LEGAL DESCRIPTIONS

THIS DESCRIBED PARCEL CONTAINS 76.23 ACRES OF LAND AS SURVEYED, BEING SUBJECT TO AND TOGETHER WITH ANY EASEMENTS, RESTRICTIONS, OR RESERVATIONS AFFECTING THIS PARCEL.

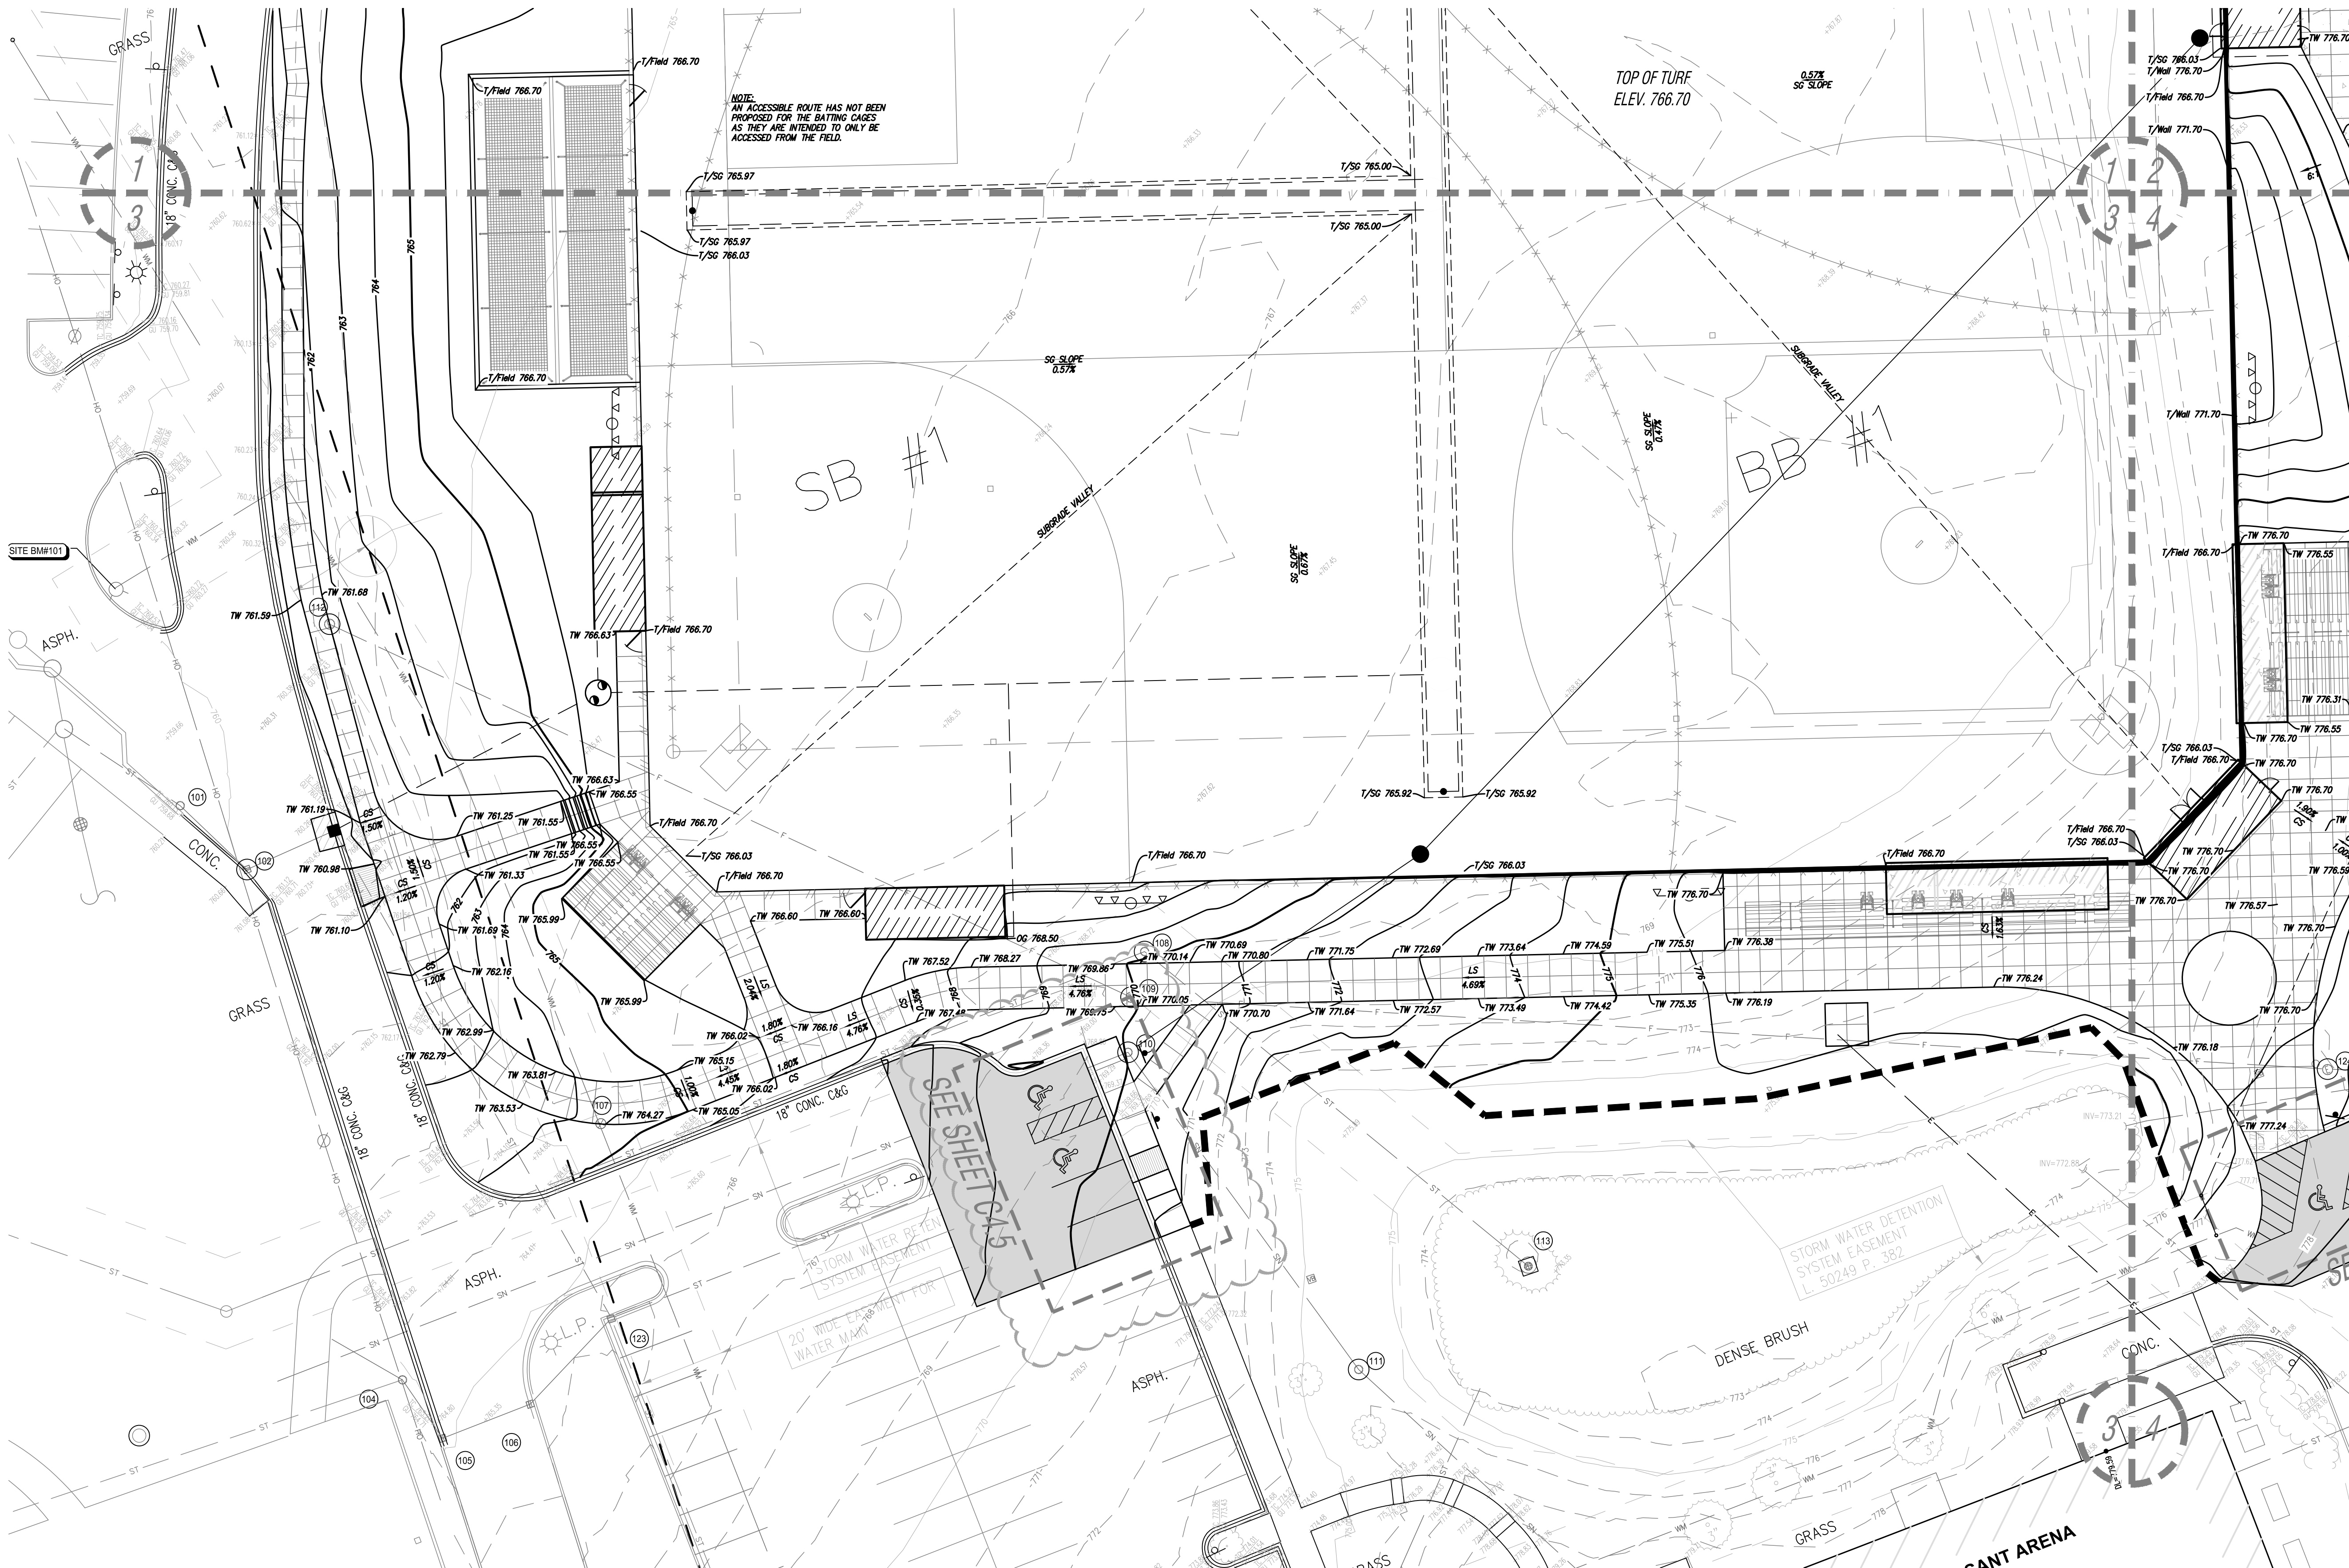
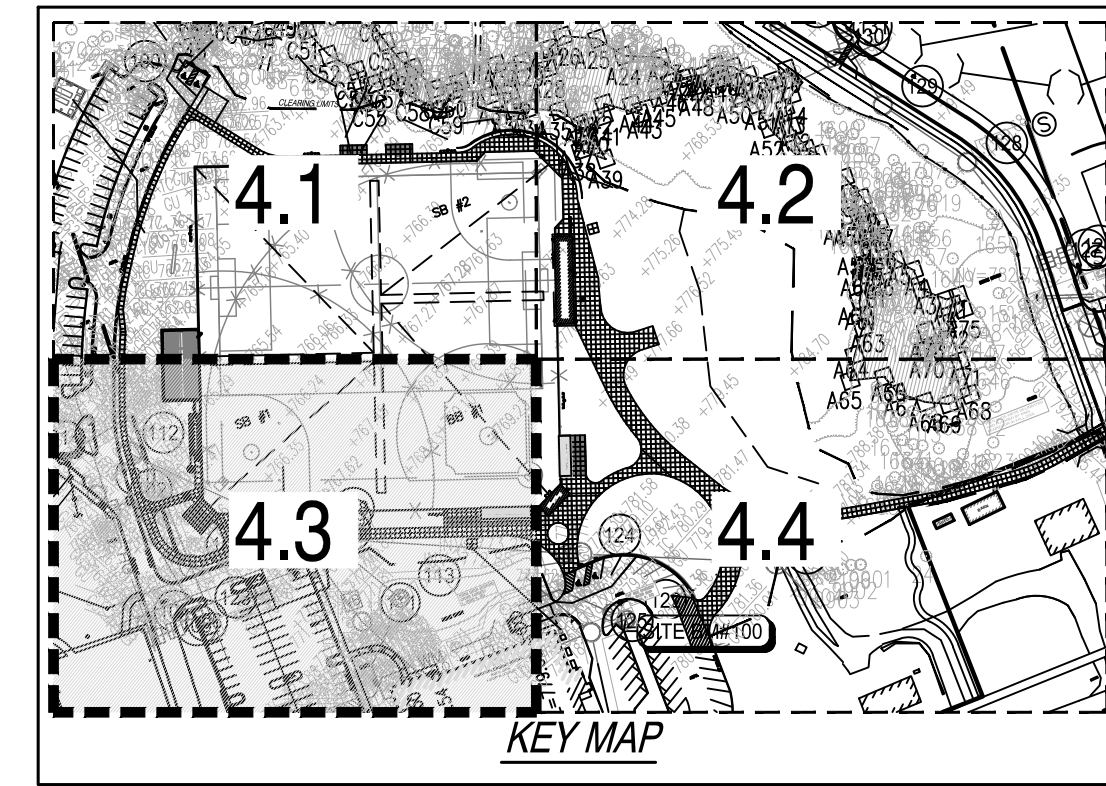
ISSUE DATE	ISSUED FOR
10/5/22	BIDS
10/24/22	ADDENDUM #1
11/23/22	PERMITS
12/2/22	SITE PLAN RESUBMITTAL
DRAWN	JA
CHECKED	
APPROVED	JA
